**California Native Plant Society • California Wilderness Coalition
Center for Biological Diversity • Defenders of Wildlife • Sierra Club**

September 14, 2021

Re: Oberon Solar Project Environmental Assessment

Figure 1. BLM-designated multi-species wildlife linkages (shown in red) in DRECP LUPA/FEIS.

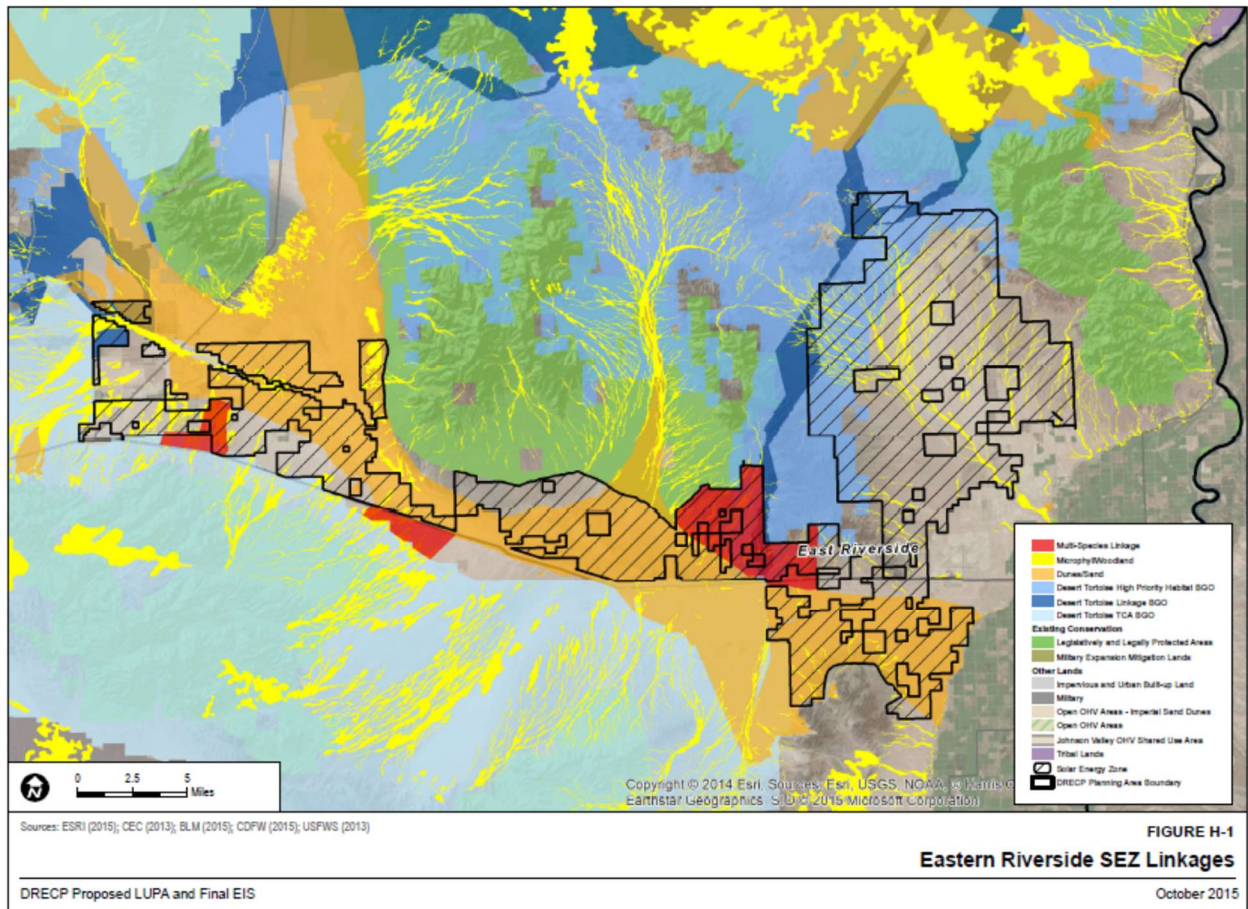
Oberon is located partially within the most westerly wildlife connectivity corridor. Figure 1 shows the overlap of the proposed Oberon project's solar array field into the BLM-designated Wildlife Connectivity Corridor. The EA fails to identify the impact to the multi-species linkage from the proposed project. Based on GIS layers from the DRECP, the fenced solar arrays cover 325 acres of the multi-species linkage. In addition, it fragments the linkage, making the linkage less functional for wildlife to move unimpeded through it (Ibid). We recommend that the EA be revised to fully analyze impacts to the multi-species linkage and comply with the DRECP.

Figure 2. Proposed Oberon Project's overlap with BLM-designated Multi-species Linkage in the Riverside-East DFA.

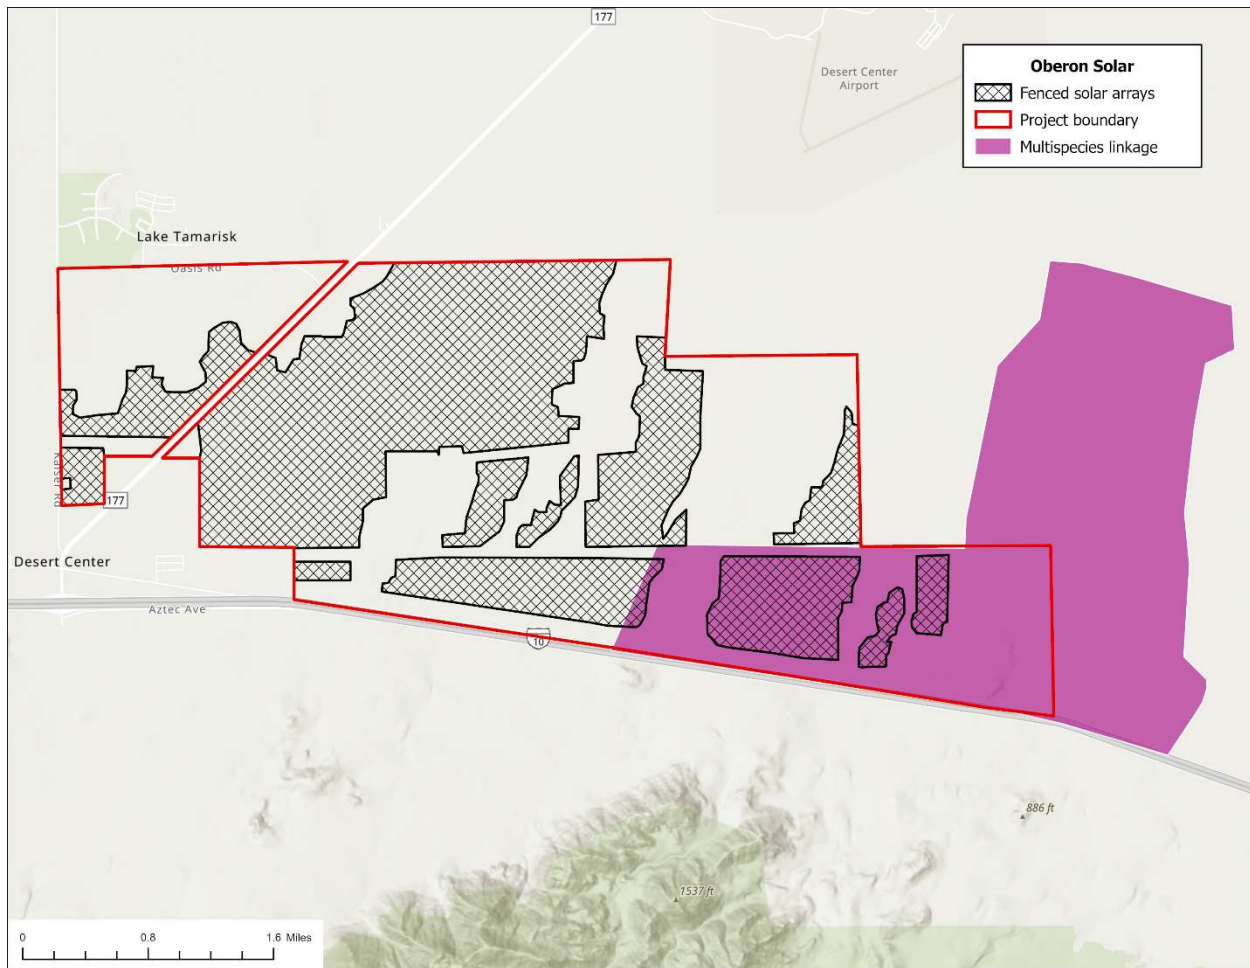
Figure 2.2 in Appendix B of the Oberon EA is troubling because it reveals the potential extent of cumulative impacts from other existing and proposed renewable energy projects in the western Chuckwalla Valley. One of those is the Easley Project, proposed by Intersect Power, which is also the proponent of Oberon. The Easley Project is located just to the north of the Athos and Victory Pass projects. Victory Pass would impact the multi-species linkage by placing solar arrays within the linkage. The Athos project, which is not on BLM-managed land and is currently under construction, has already constricted over half of the northern part of the linkage on the west. The proposed Easley project's southern or northern areas have the potential to block the northern part of the linkage, thereby completely eliminating the functionality of the multi-species linkage. BLM must comply with the DRECP and maintain the wildlife linkages and analyze all the known direct, indirect and cumulative impacts to the multi-species wildlife linkage.
